Chiller No1. Mod: YKFBFAH65CSD Ser: PLGMH50288
 Chiller No2. Mod: YKFBFAH65CSD Ser: PLGMH50294
 Chiller No3. Mod: YKFBFAH65CSD Ser: PLGMH50287
 Chiller No4. Mod: YKFBFAH65CSD Ser: PLGMH50290

Following on from my site visit last week, please find a breakdown of the problems encountered. The above site suffered from Power Faults on a running Chiller during the start sequence of another. Initial investigations of the Chillers CM2 Motor Protection Module's three-phase rectified input signal, showed irregularities. We would expect a 300Hz ripple (3.3mSecond period) on the input signal, denoting the rectification of the 3 Current Transformer signals from each of the phases to the motor. With the aid of an oscilloscope we can see that we have only a 150Hz ripple (6.6mSecond period) with a higher amplitude than we would expect. Refer to Figure 01.

Figure 02.

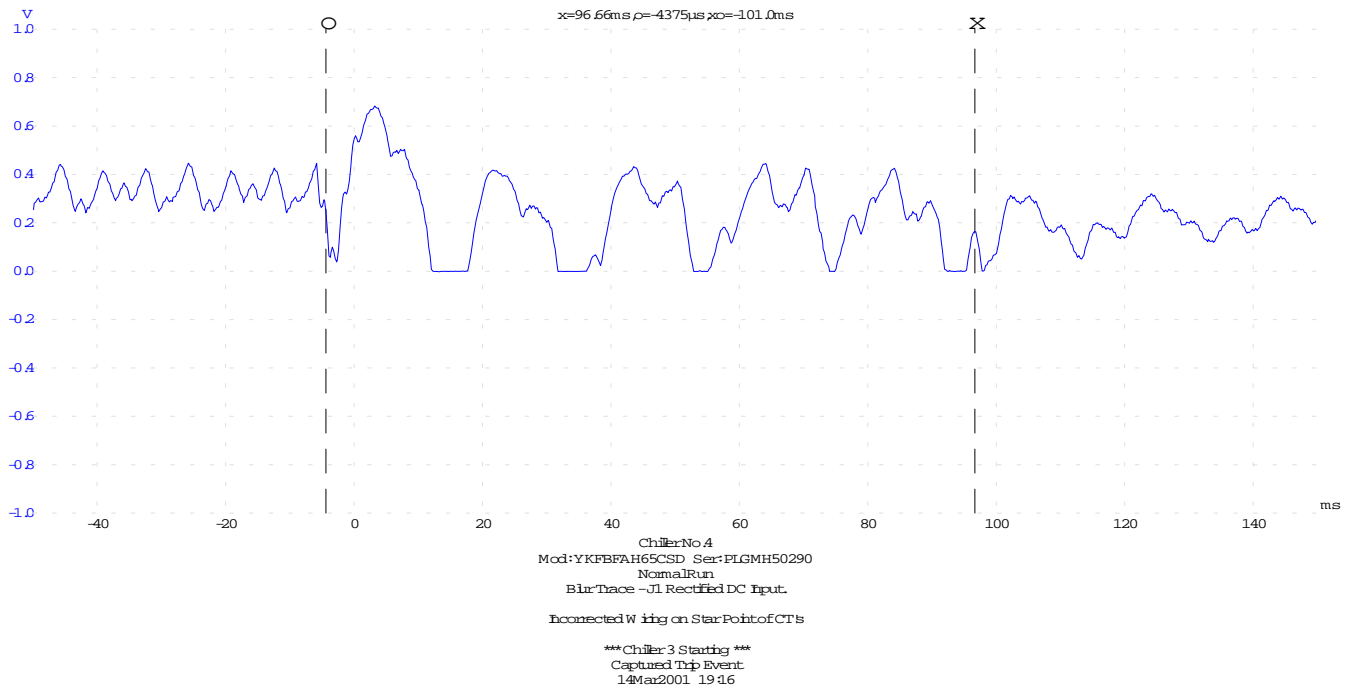
We actually captured a trip event on a running Chiller with the mis-wiring still in place, as reflected in Figure 02. The whole event took around 100 m seconds from initial start of the other Chiller to the running compressor's contactor dropping out.

Figure 03.

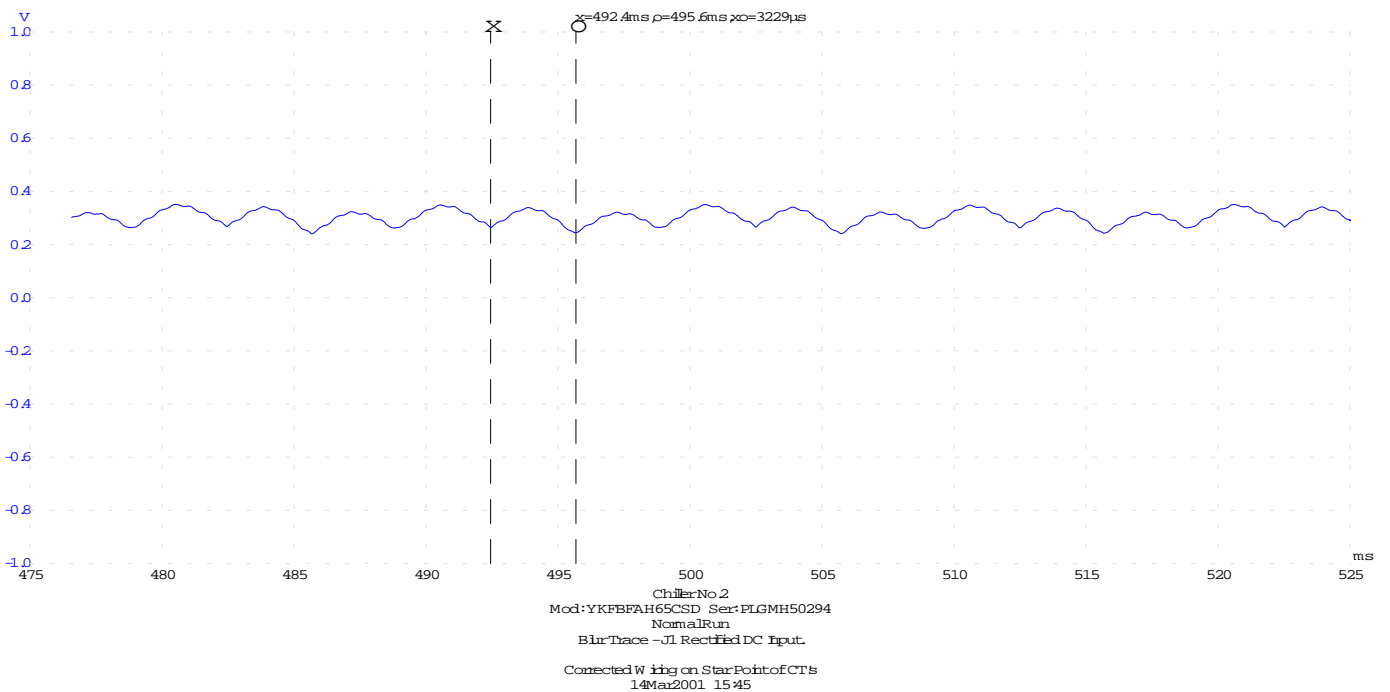
After removing the Earth lead from all the chillers CM2 Modules CT's Star points, the correct waveform was captured as per Figure 03.

Figure 04.

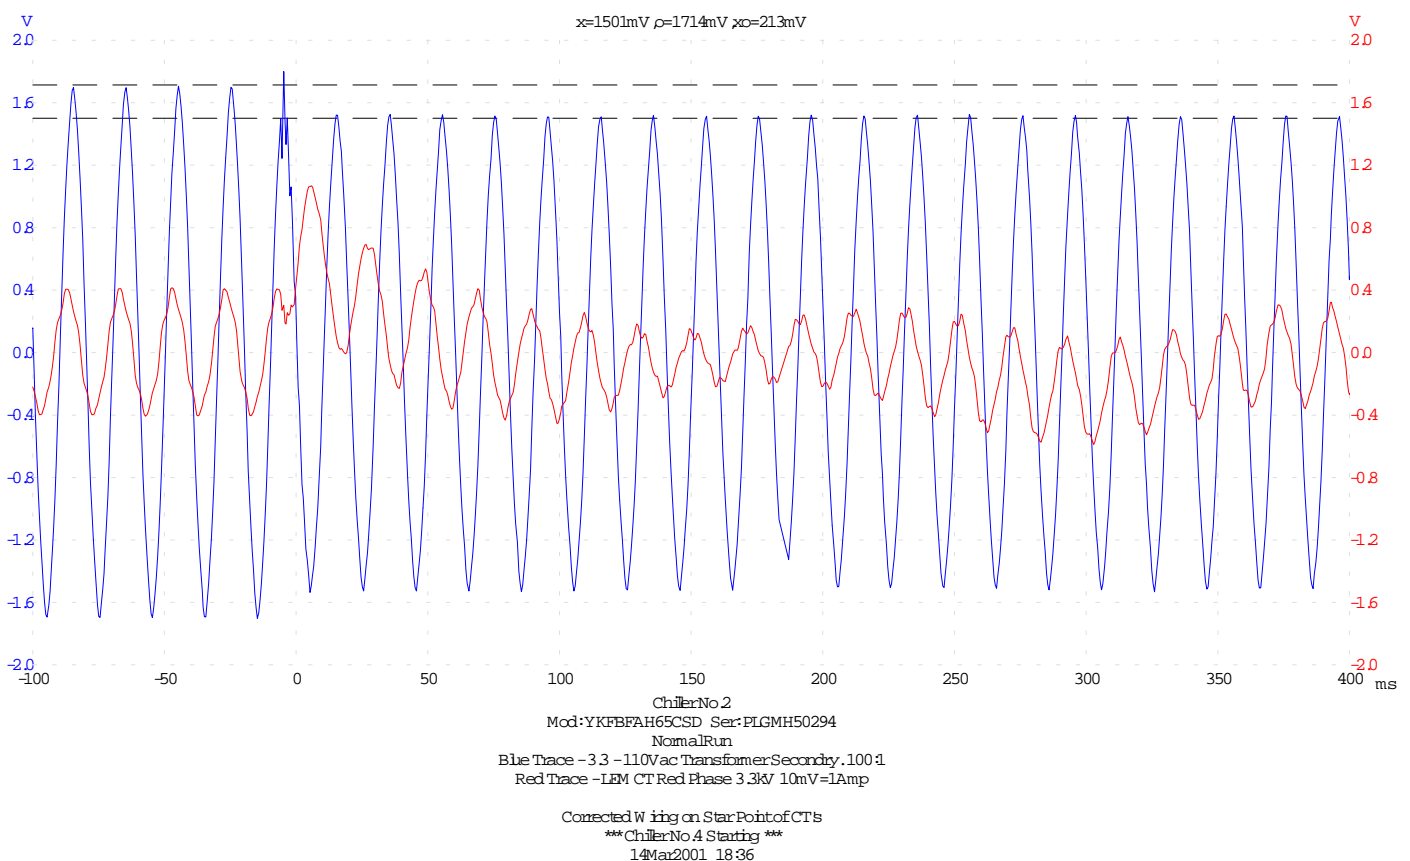
Although the Power Faults have reduced, the problem behind the trips is still present during every start of a compressor. This event is a reduction in the 3.3kV power supply to the running compressor when another Chiller starts. Although I did not directly measure the 3.3 kV network during one of these events, I did capture a large volt drop on a 3.3kV to 110Vac transformer output in the running chillers starter cabinet. This volt drop was measured as a 14% reduction on line voltage as reflected in Figure 04.

This captured event also shows the running chillers current waveform phase shifting at the instant the other Chiller is started. This can be explained as reduced Line Voltage at the instant the other starting compressor is flashed up, causing the running driveline to decelerate and the motor to be driven by the compressor and it's own rotor's inertia. The back EMF produced by the motor exceeds the line voltage and current from its windings is dumped back into the 3.3 kV Network, assisting the starting compressor to break away. This phase shift, an almost anti-phase distinguishes between the motor being a load to a generator in relation to the 3.3kV Network. This current dumping event lasts between 1 to 4 cycles. The oscillating current distortion after this event is a function of slip and acceleration whilst the running motor achieves synchronous speed.

Figure 05.

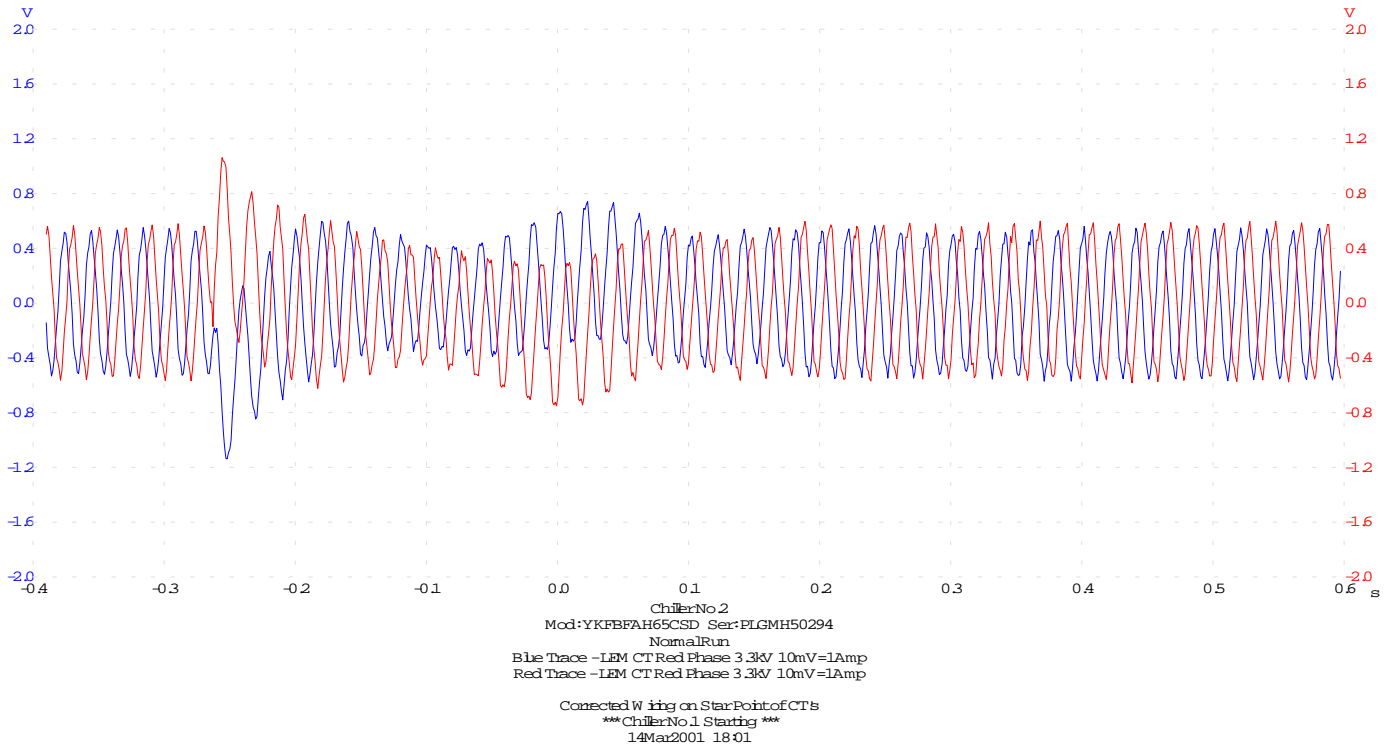
The above event can be seen even better when using two current probes on the motor leads. It can be seen from all our data collected (Figure 05) that around 50 to 60 Amps RMS is being dumped back into the 3.3 kV Network, this calculates to around 160 kW of power.

Figure 06.

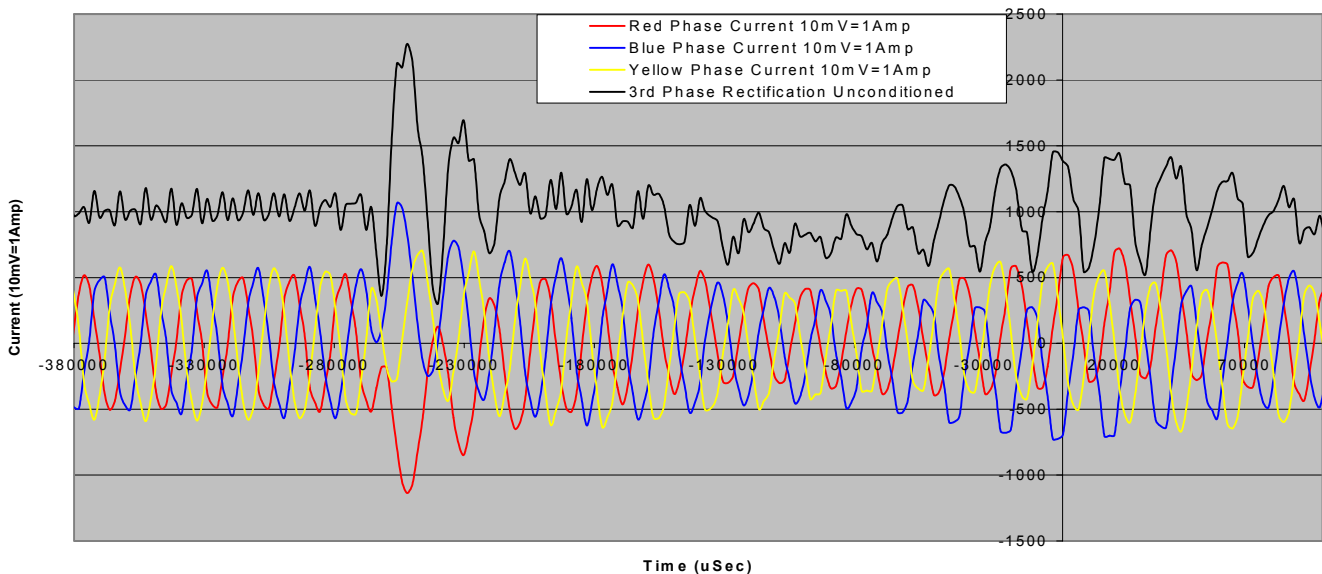
To show you the theoretical resultant rectified waveform to the CM2 module of the above waveform we apply a unitary algorithm to calculate the third phase current draw. (Only 2 inputs on my oscilloscope) Using the absolute value from all three phases we can show the resultant rectified signal to the CM2 Module. (Figure 06) As you can see there are several major dips in the signal (Black Trace) that once exceed the 15% minimum current threshold will result in a Power Fault Shutdown. This theoretical calculated rectified signal takes the exact form as a captured scope trace as reflected in Figure 07. This suggests that even with the corrected earth wiring the real rectified waveform to the CM2 Module is very close to a trip condition as the 3.3kV Network now stands.
